NORTH SAN MATEO COUNTY SANITATION DISTRICT

Subject: Comments Regarding Tentative Order Reissuing the North San Mateo County Sanitation District's NPDES Permit (CA0037737)

Comments on Tentative Order for Renewal of NPDES Permit January 5, 2012

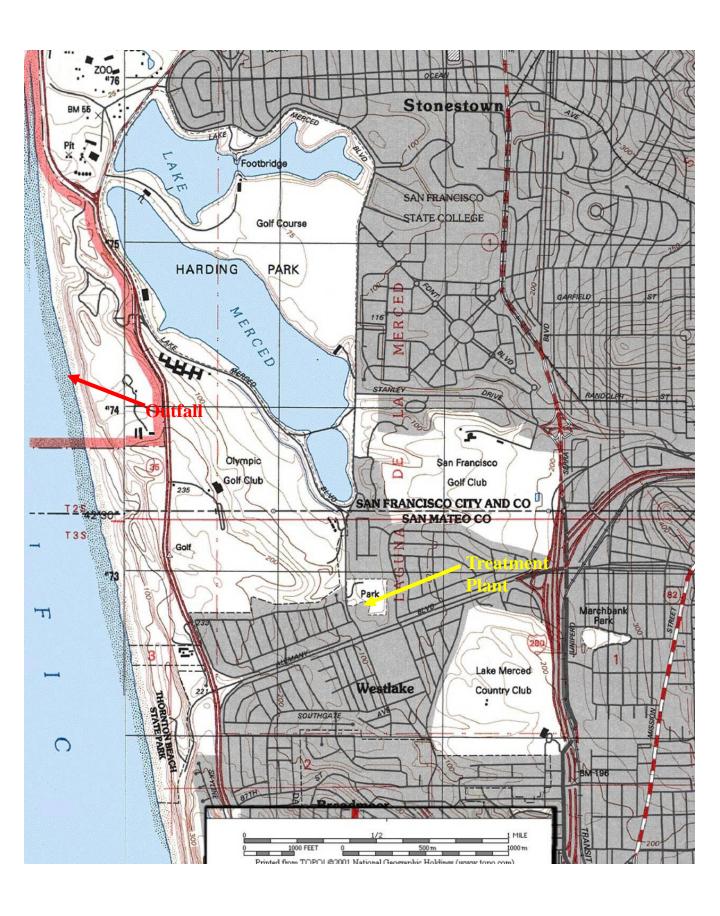
3. The District requests that the Facility Location Topographic Map be revised to indicate the actual location of the treatment plant.

In Figure B-2 of the Tentative Order, the arrow indicating the Treatment Plant location is incorrectly placed. The District has attached a file to the e-mail accompanying these comments which includes an updated version of this figure (see the file "Figure B-2 Facility Location Topo Map.ppt"). The District requests that this figure be updated to indicate the correct location of the treatment plant.
